Access Compliance Report

Public Rights-of-Way

(Pedestrian Signals)

Intersection ID: N/A	Main Street:	Cross Street: N/A	Location: N/A
ADA ID: 33549EE5A830	Signal Type: Two Push Buttons-Non APS	Overall Compliance: No	Severity Score: BTN 1:N/A BTN 2: N/A No BTN: N/A
Codes/Mitigation Info/Possible Solution		Field Measurements/Component Compliance

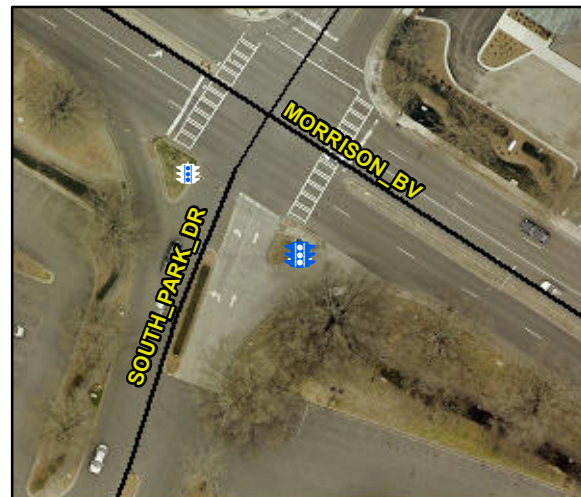
Compliance	Description	Data	Compliance	Description	Data
	Button Count	Button2	N/A	Distant to Additional Button (in)	N/A
	Additional Button Present?	No		Additional Button ID	N/A
N/A	Signal Buttons Required?	N/A	N/A	Additional Ped Posts Required	N/A
	How Many Ped Street Xings?	3		Located In An Island/Median?	Yes
N/A	B 1 Sign Present?	Yes	N/A	B 2 Sign Present?	Yes
Yes	B 1 Sign Purpose?	Yes	Yes	B 2 Sign Purpose?	Yes
Yes	B 1 Sign Lettering & Contrast?	Yes	Yes	B 2 Sign Lettering & Contrast?	Yes
Yes	B 1 Parallel To XWalk?	Yes	Yes	B 2 Parallel To XWalk?	Yes
Yes	B 1 PAR to Button?	Yes	Yes	B 2 PAR to Button?	Yes
Yes	B 1 PAR to XWalk?	Yes	Yes	B 2 PAR to XWalk?	Yes
Yes	B 1 Clear Floor Space?	Yes	No	B 2 Clear Floor Space?	No
N/A	B 1 FWD Approach?	No	N/A	B 2 FWD Approach?	Yes
N/A	B 1 FWD Approach Constrained?	N/A	N/A	B 2 FWD Approach Constrained?	No
N/A	B 1 FWD Approach Reach (in)	N/A	No	B 2 FWD Approach Reach (in)	11.0

N/A	B 1 FWD Approach Width (in)	N/A	N/A	B 2 FWD Approach Width (in)	N/A
N/A	B 1 FWD Approach Obstruction?	N/A	N/A	B 2 FWD Approach Obstruction?	Yes
N/A	B 1 FWD Approach Obstruction Dist (in)	N/A	N/A	B 2 FWD Approach ObstructionDist (in)	11.0
N/A	B 1 PARA Approach?	Yes	N/A	B 2 PARA Approach?	Yes
N/A	B 1 PARA Approach Constrained?	No	N/A	B 2 PARA Approach Constrained?	No
No	B 1 PARA Approach Reach (in)	20.0	No	B 2 PARA Approach Reach (in)	11.0
N/A	B 1 PARA Approach Width (in)	N/A	N/A	B 2 PARA Approach Width (in)	N/A
N/A	B 1 PARA Approach Obstruction?	Yes	N/A	B 2 PARA Approach Obstruction?	Yes
N/A	B 1 PARA Approach Obstruction Dist (in)	13.0	N/A	B 2 PARA Approach ObstructionDist (in)	11.0
Yes	B 1 Clear Floor Space Slope (%)	1.3	N/A	B 2 Clear Floor Space Slope (%)	1.2
Yes	B 1 Clear Floor Space XSlope (%)	0.2	N/A	B 2 Clear Floor Space XSlope (%)	0.1
N/A	B 1 PAR Slope (%)	1.6	N/A	B 2 PAR Slope (%)	2.4
No	B 1 Height (in)	49.0	No	B 2 Height (in)	50.5

Yes	B 1 Clear Xing Direction?	ClearlyMarked	Yes	B 2 Clear Xing Direction?	ClearlyMarked
	B 1 Crossing Direction	To NE		B 2 Crossing Direction	To NW
Yes	B 1 DistanceTo XWalk (in)	0.0	Yes	B 2 DistanceTo XWalk (in)	0.0
No	B 1 DistanceTo Curb (in)	89.0	No	B 2 DistanceTo Curb (in)	82.0
Yes	B 1 Diameter (in)	2.0	No	B 2 Diameter (in)	2.0

Possible Solutions: Replace Signal Push Button With APS Button on New Post. Remove & Relocate Sign.
